# Water Basis of Design Report For 4440 Saddlebag Trail at 4440 North Saddlebag Trail Scottsdale, Arizona 85251

As-noted comments (for posterity): 1) gpm (not gpd) values from DS&PM table are to be used with peaking factors

Sewer Basis of Design Report For 4440 Saddlebag Trail at 4440 North Saddlebag Trail Scottsdale, Arizona 85251

As-noted comments to address on plans: 1) Utilize MAG detail 440-3 for 6" service connection.

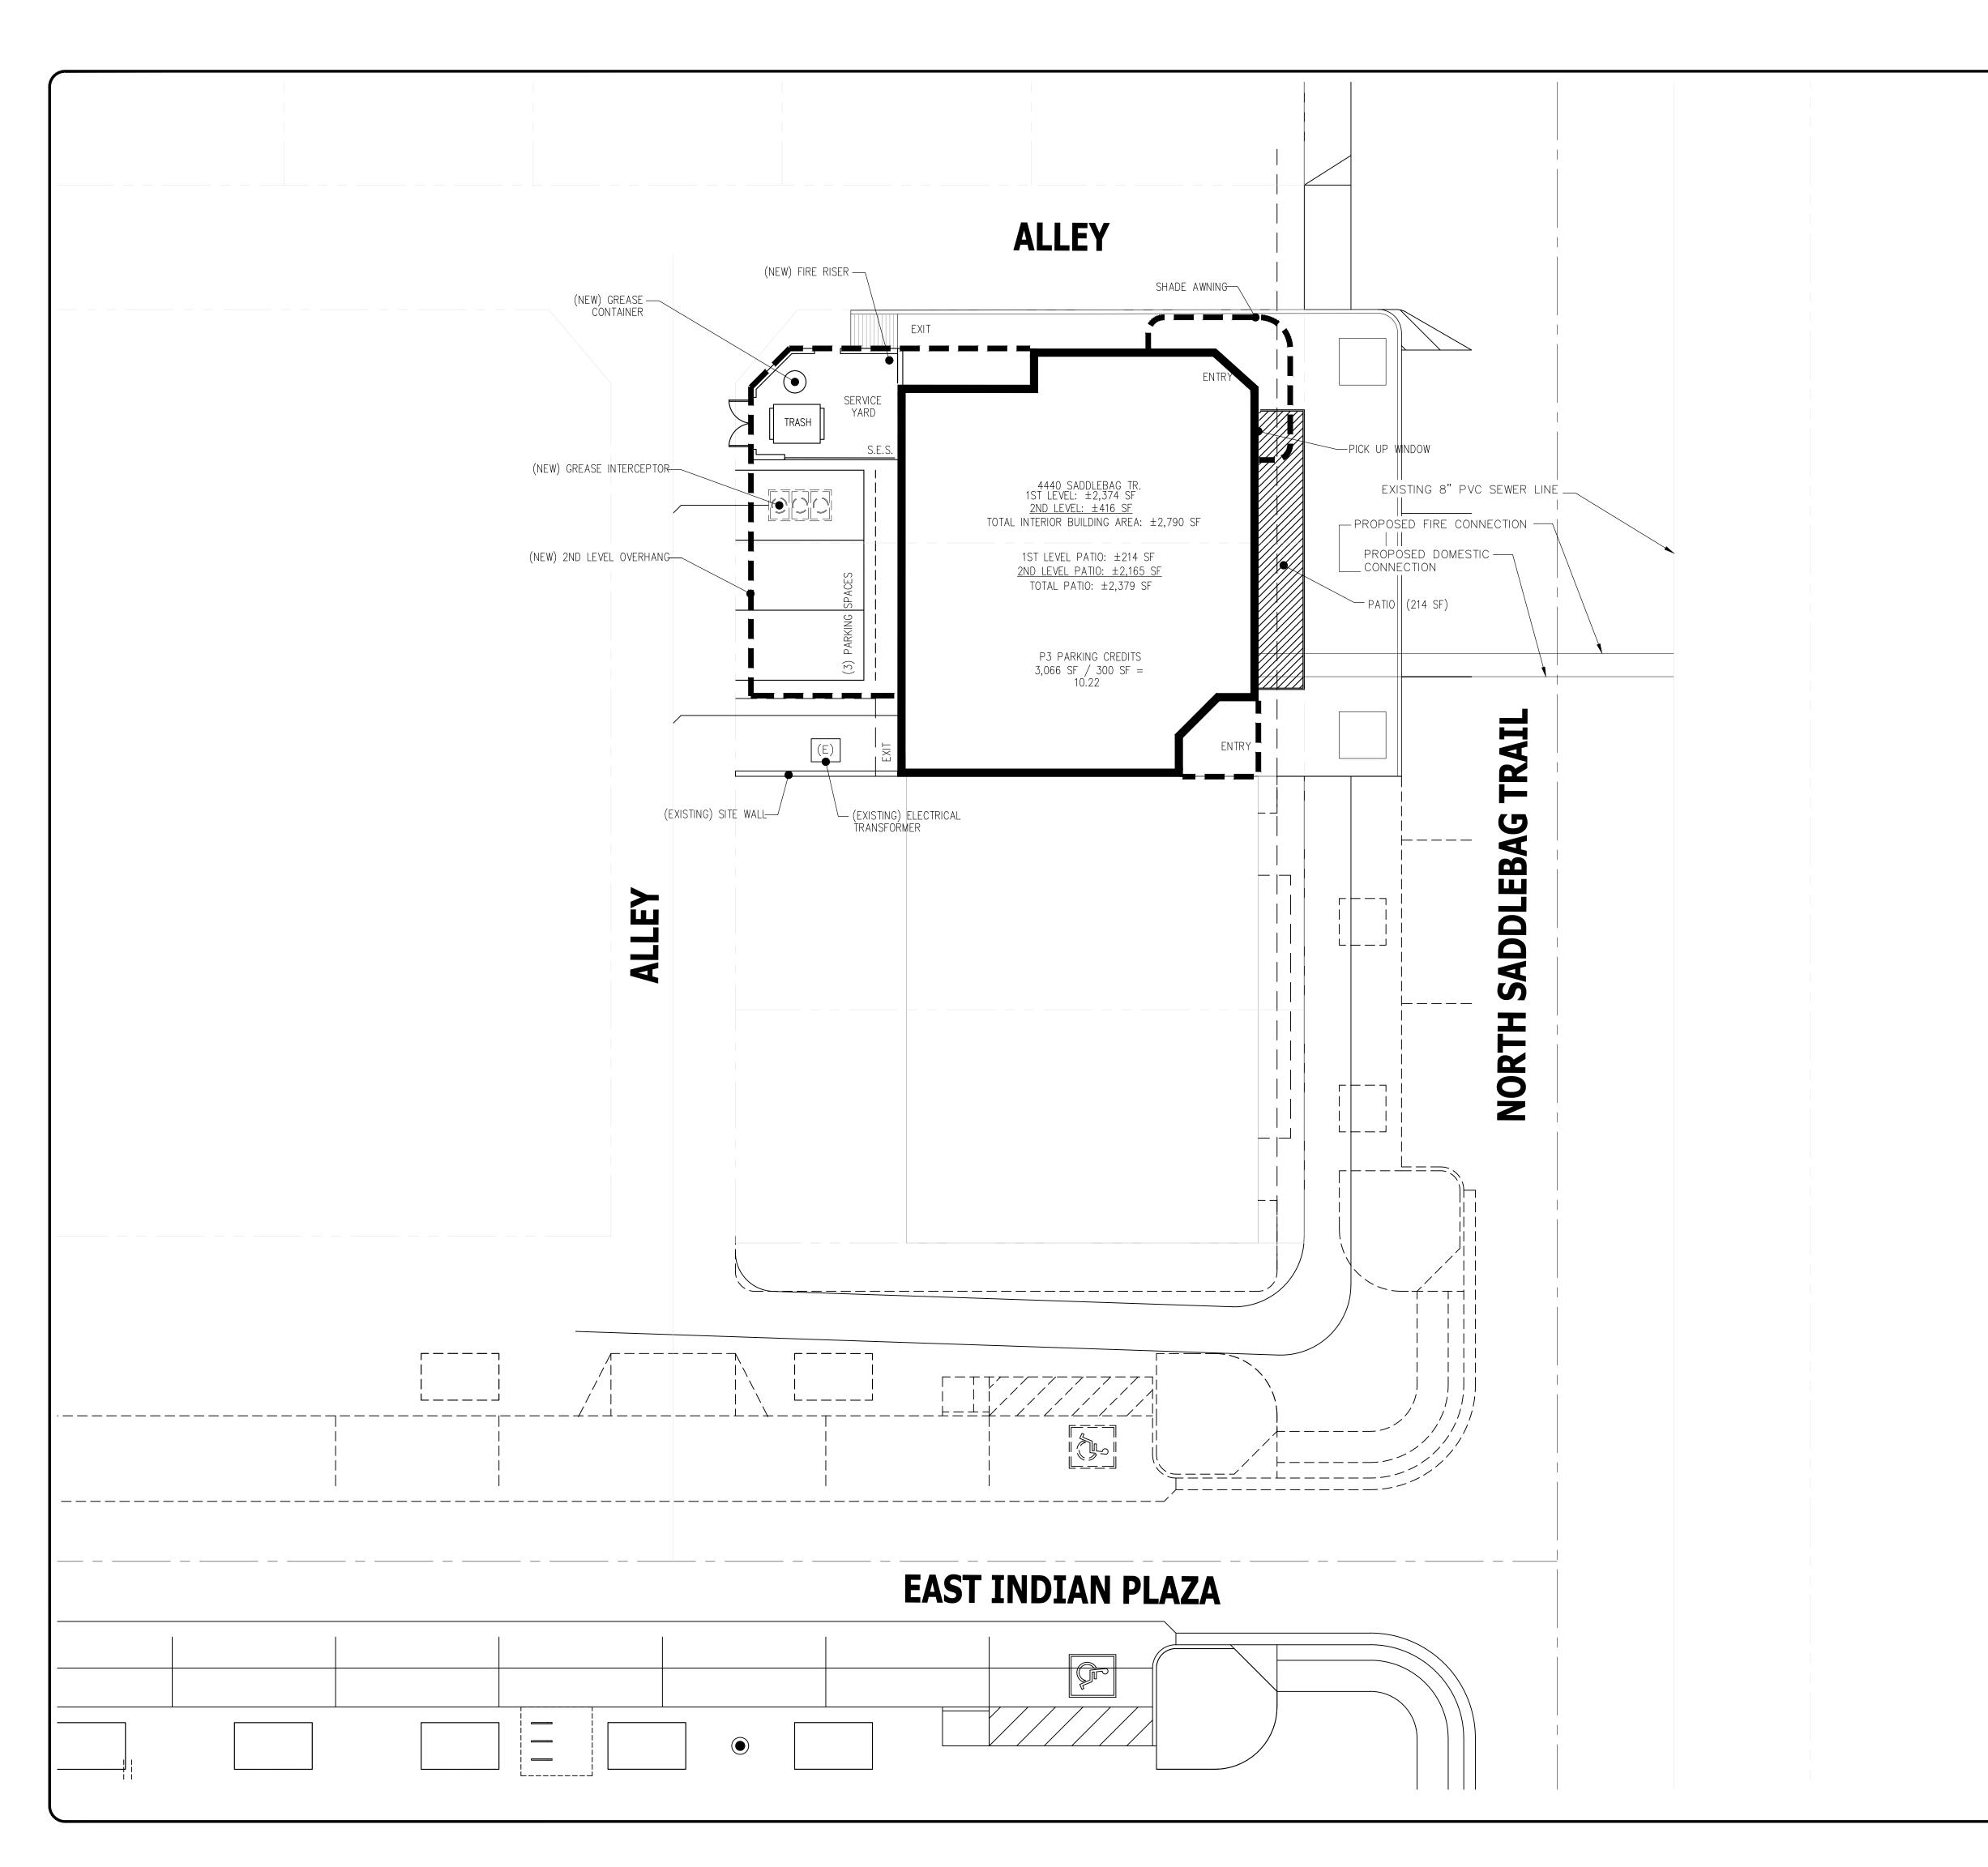
As-noted comments to address on plans: 5) Water service line to be min 1" type K copper

6) Meter required to be located in easement in safe and accessible location for City. Sizing per IPC fixture count flow plus "continuous flow" X1.5 and use DS&PM table.

7) RPP backflow required on domestic meter in safe and accessible location to City but on private property.

8) PRV required for building due to static pressure.

9) Fire line riser room not shown, discuss and address details with fire dpt.
